# Environmental Impact Statement

Request for Project Change 4

Response to Submissions Report

June 2019

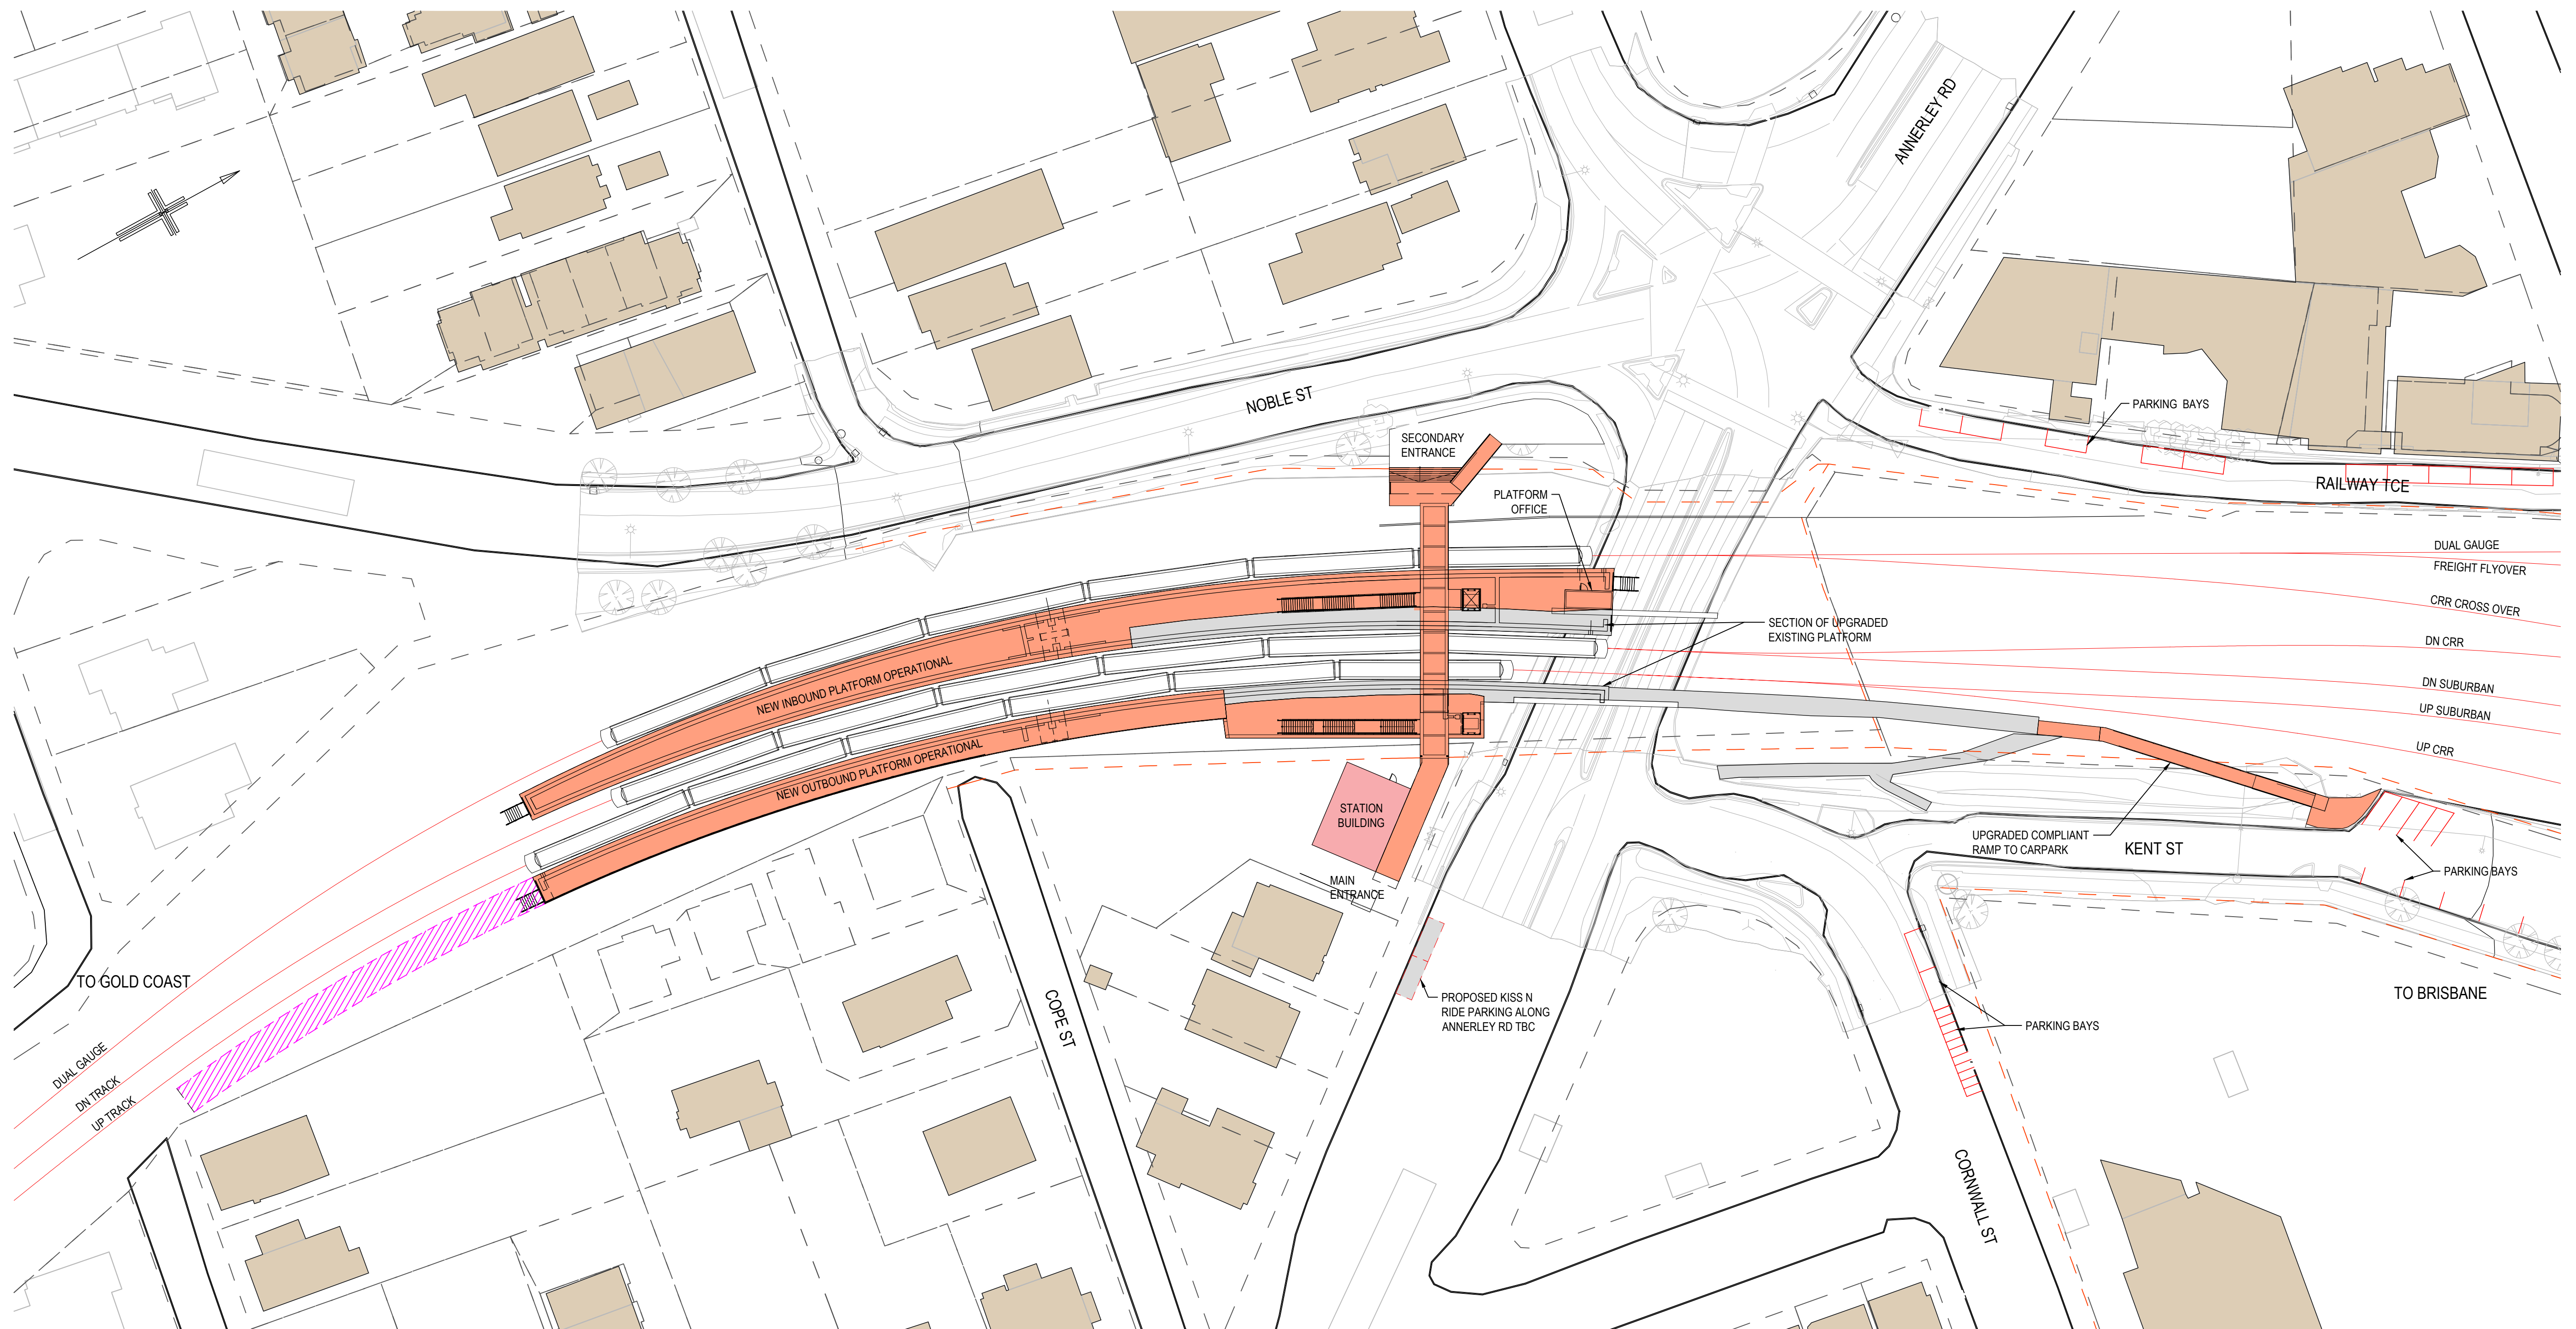
In response to submissions requesting further detail about the Moorooka and Dutton Park Stations, updated drawings are provided in **Appendix 2** for both these stations.

PROPERTY IMPACT PLANS SHEET 11				
Drawn	ENGINEERING CERTIFICATION (RPEQ)			
	ENG. AREA	NAME	SIGNATURE	NO. DATE
Designed

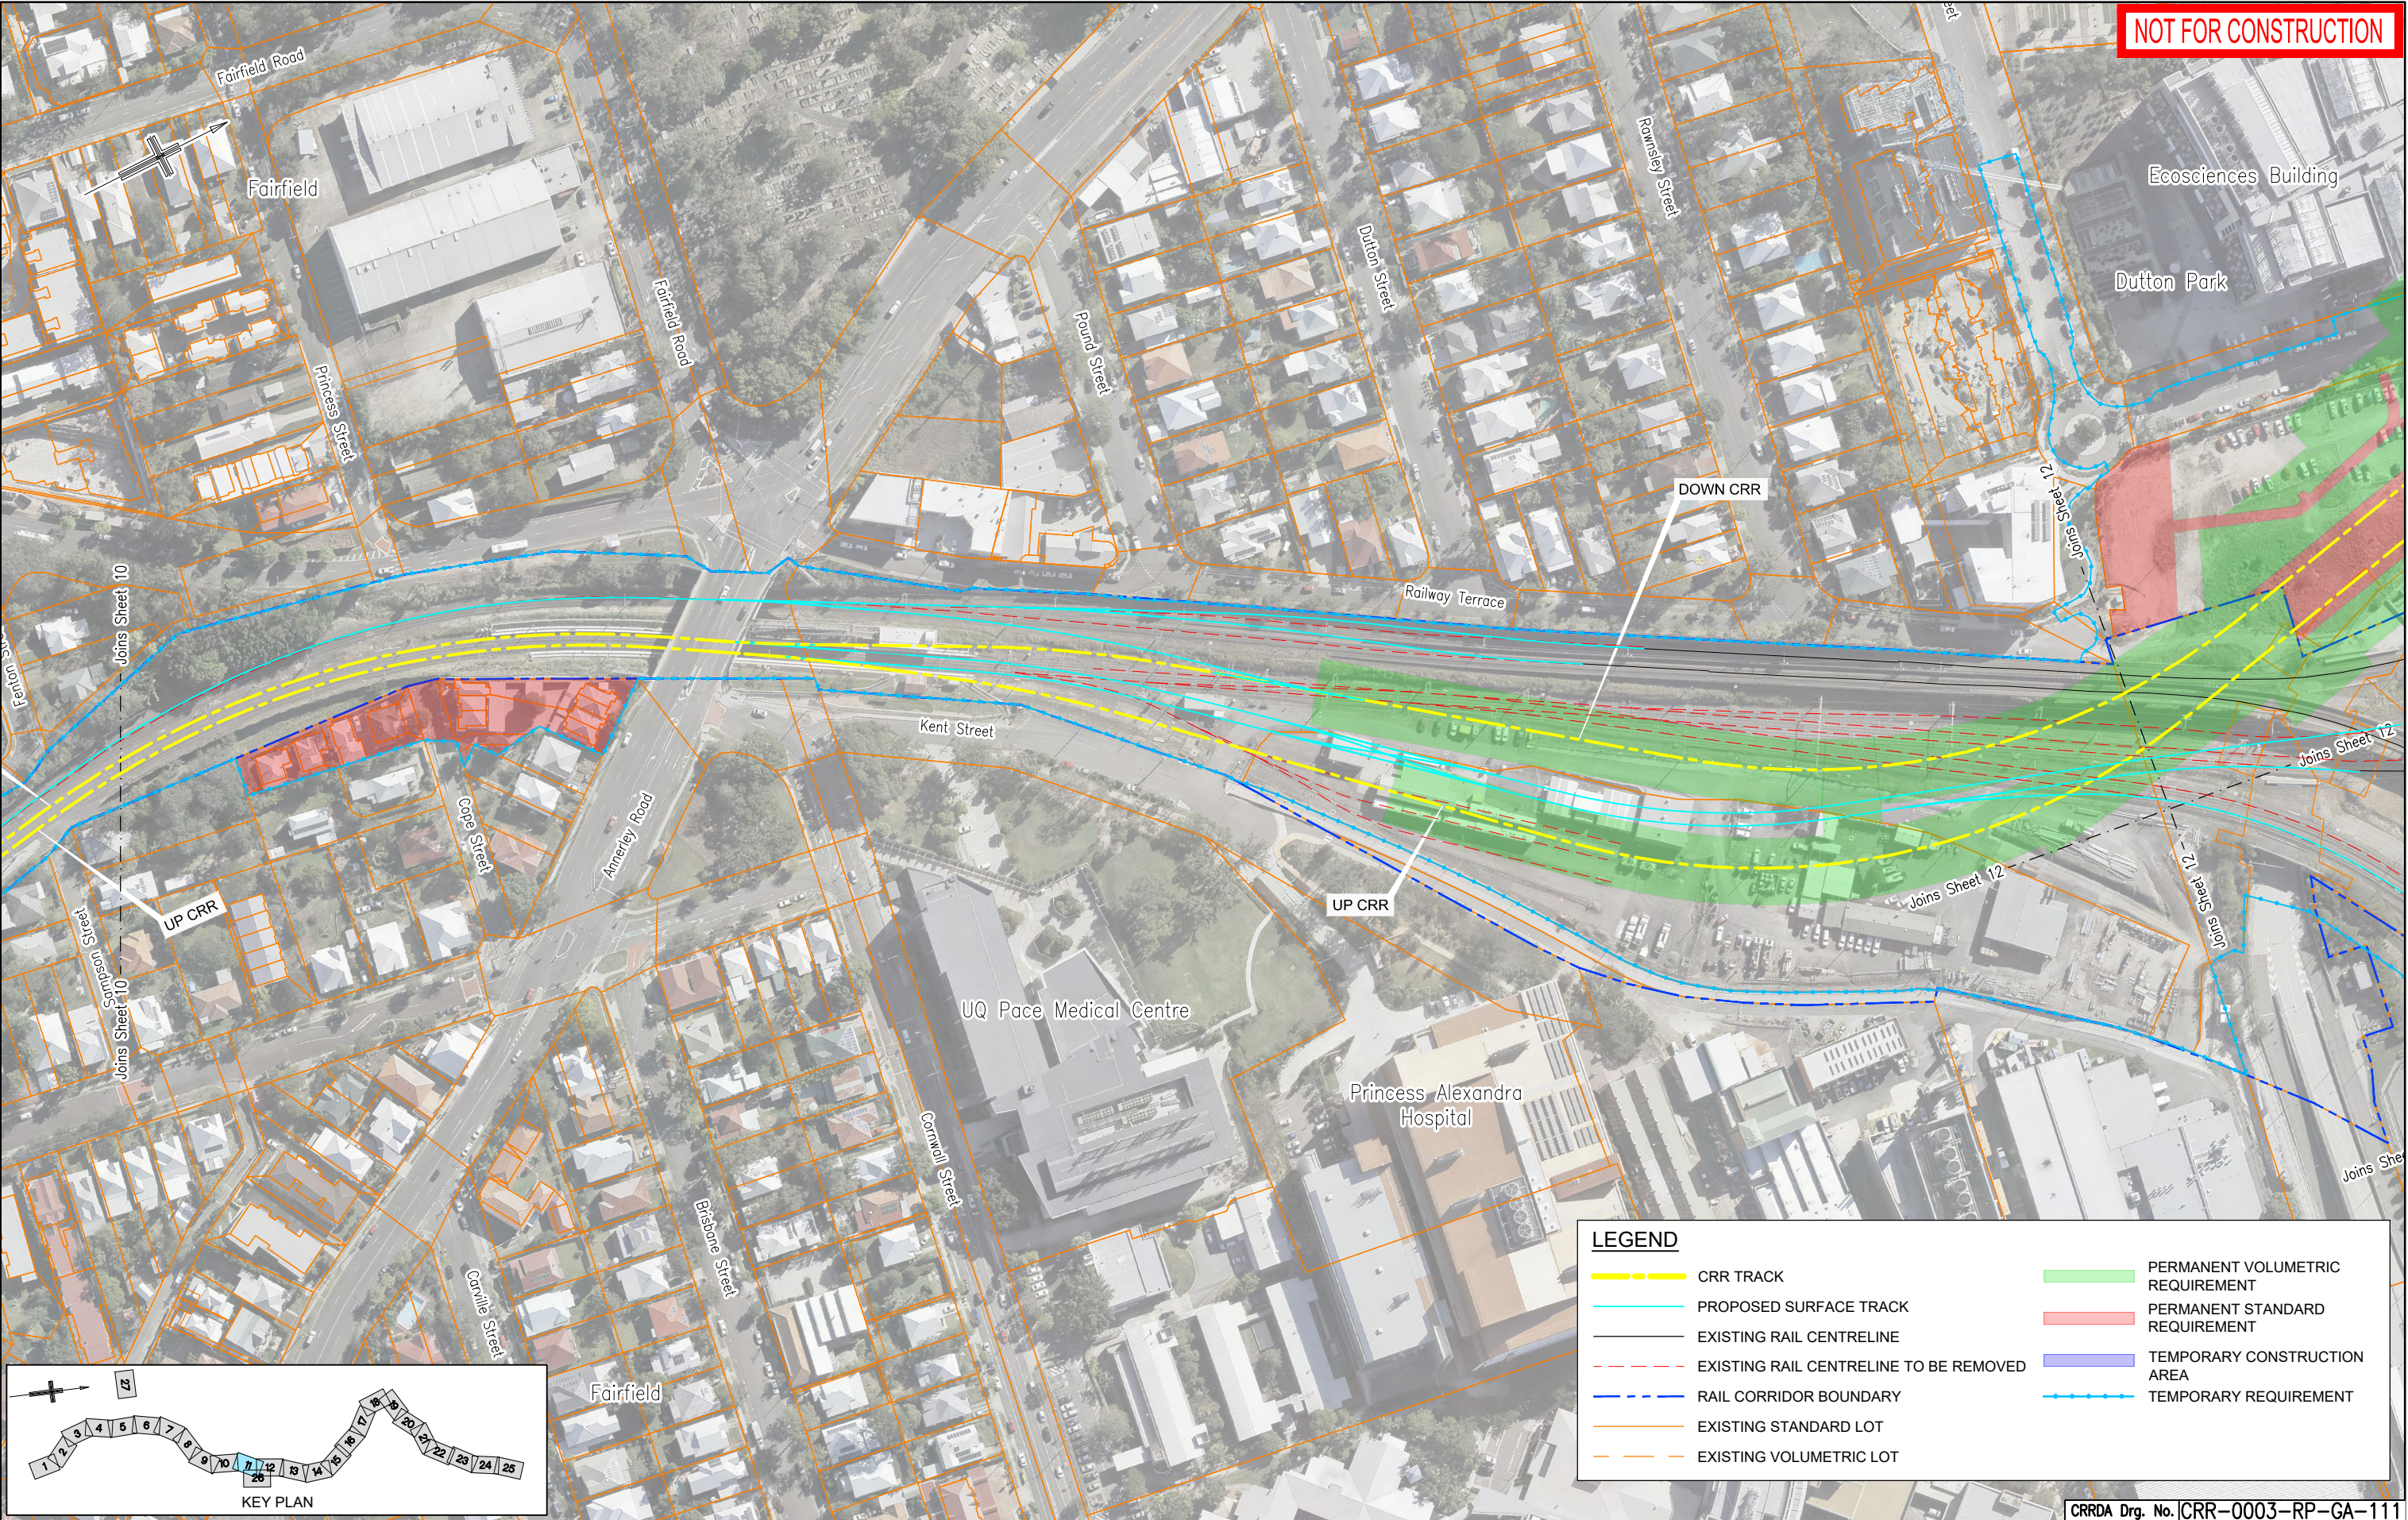
The Property Impact Plan Sheet 11 has been revised to include an easement that would have been severed by the acquisition of properties in Cope Street required for the upgrade of Dutton Park Station.

C	REVISED TO SUIT PUBLIC CONSULTATION COMMENTS	17.06.19	
B	MINOR REVISIONS TO RfPC4 ISSUE	29.09.19	
A	RfPC4 ISSUE	24.04.19	
Revisions/Descriptions		Certification	Date
			Microfiled

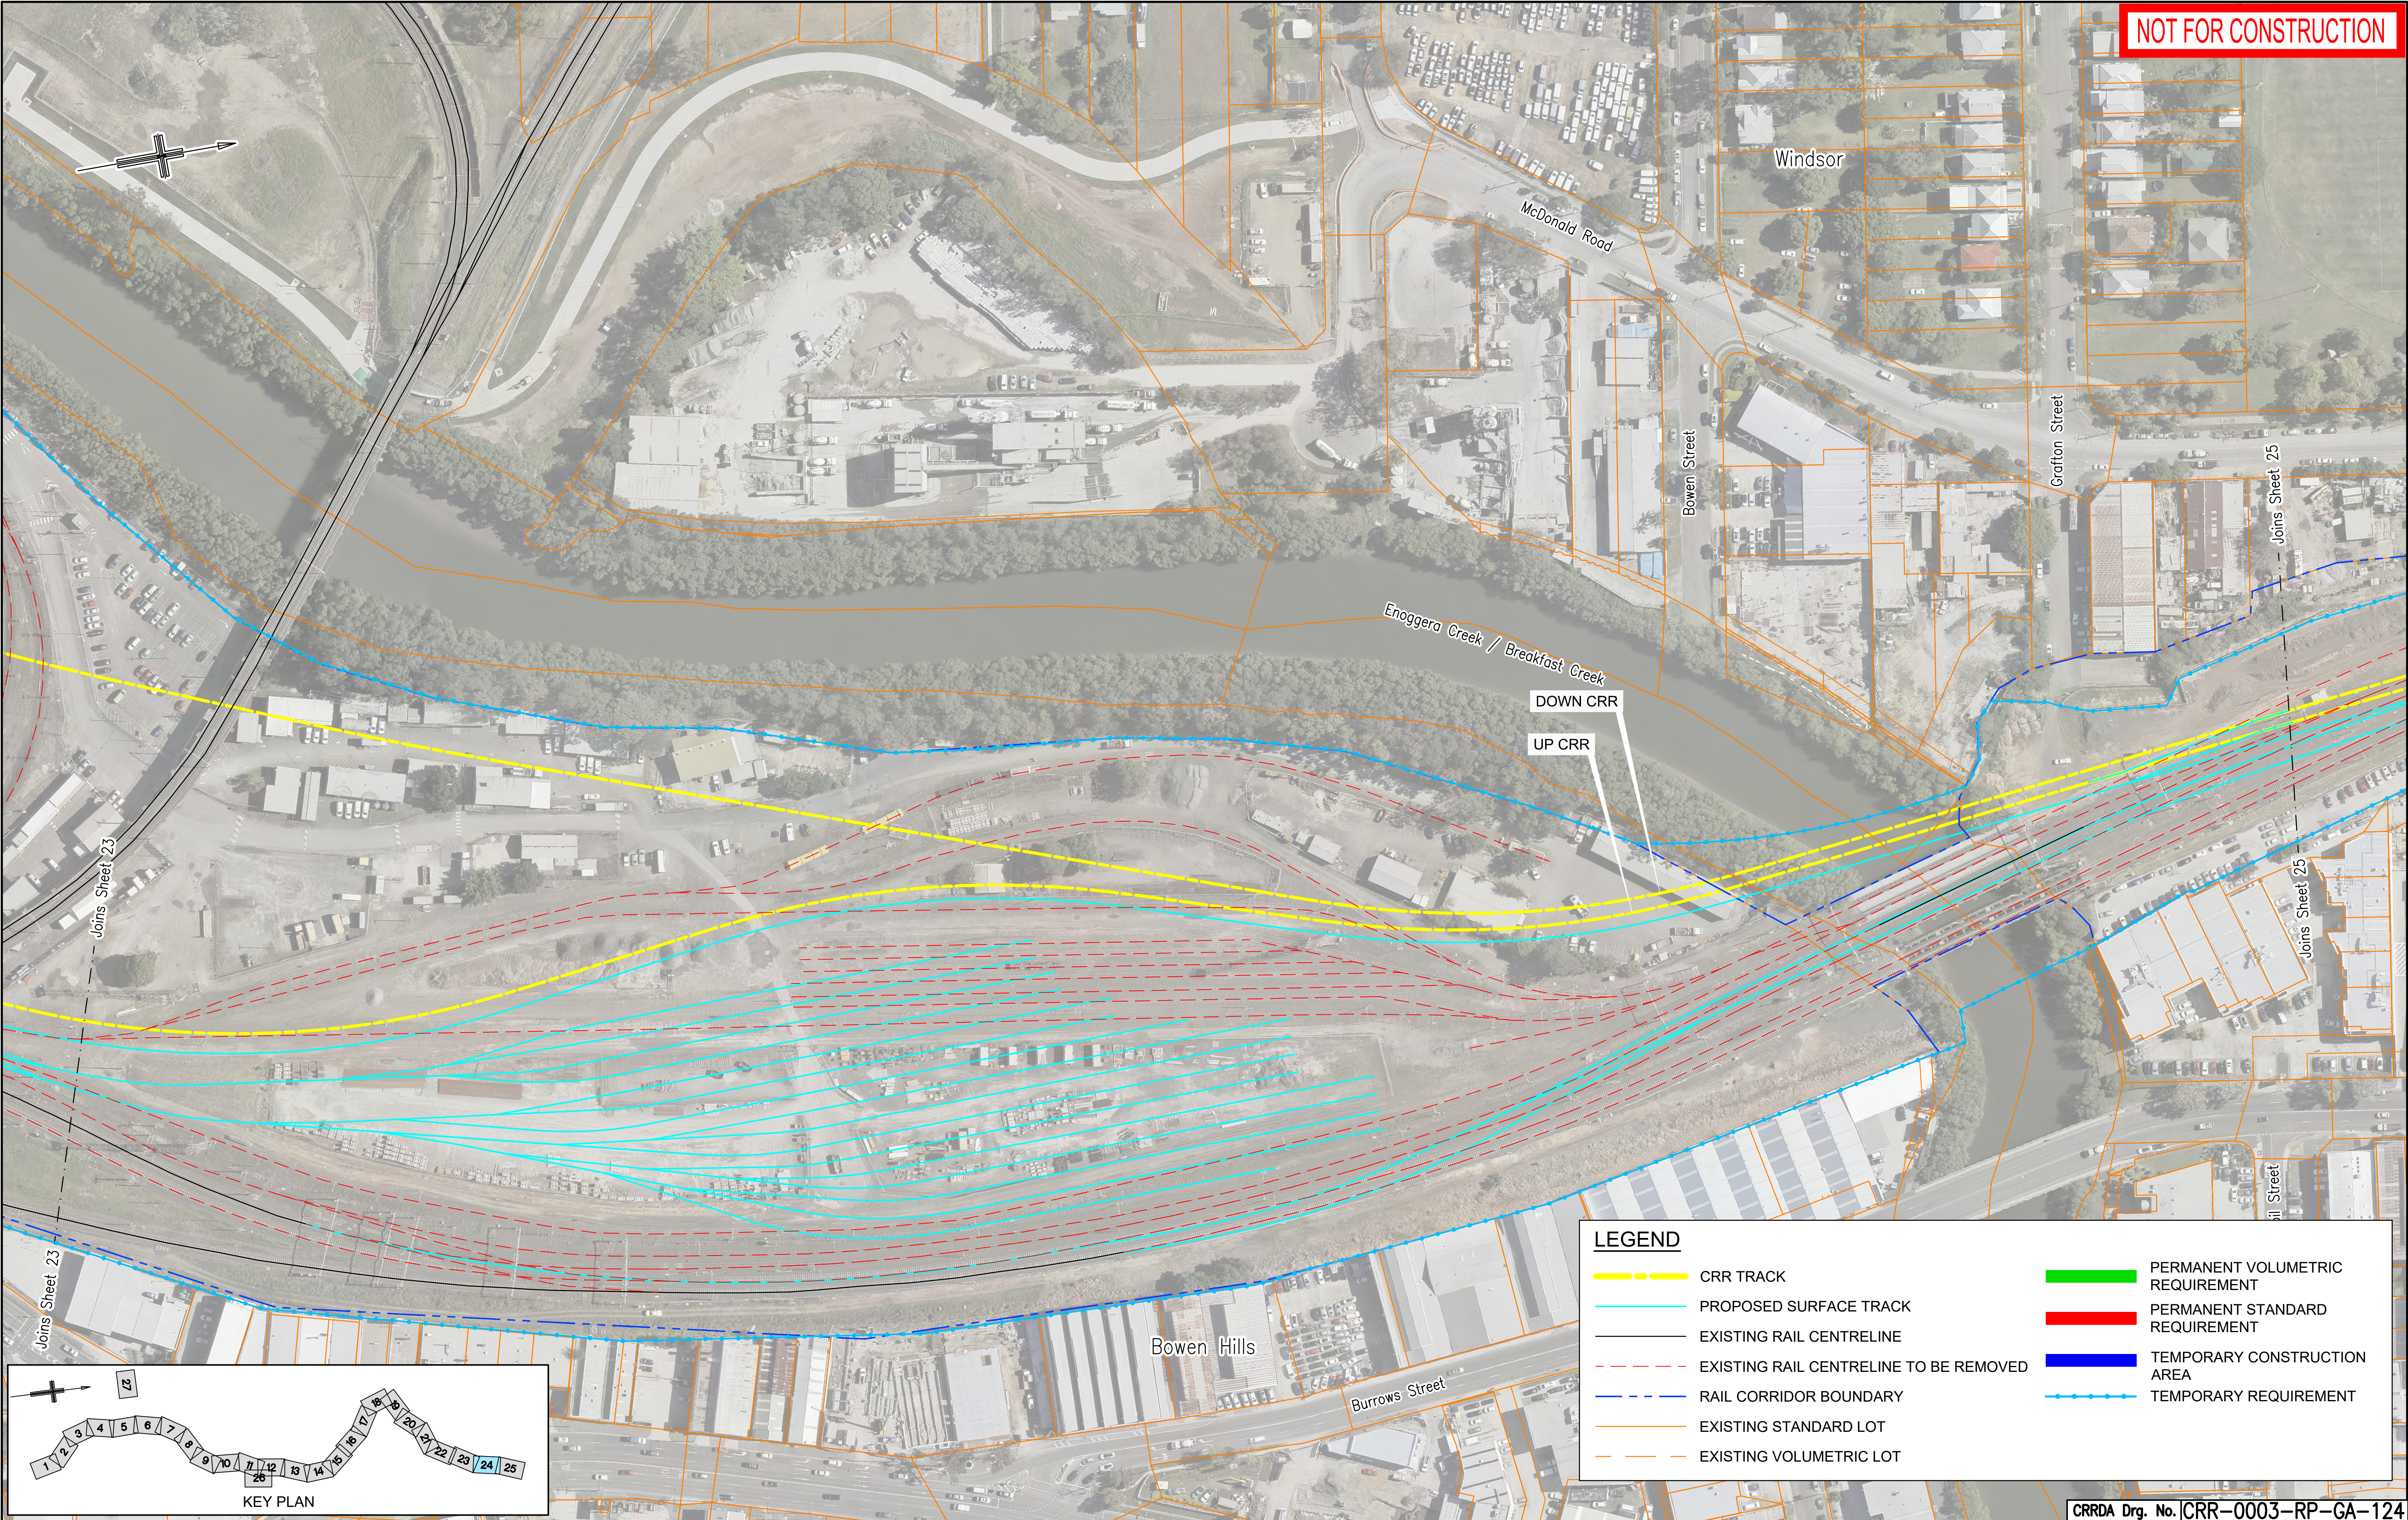
The Property Impact Plan Sheet 24 has been revised to amend the land area to be affected by Project works associated with the demolition and removal of the truss bridge over Breakfast Creek downstream of the main rail bridge.
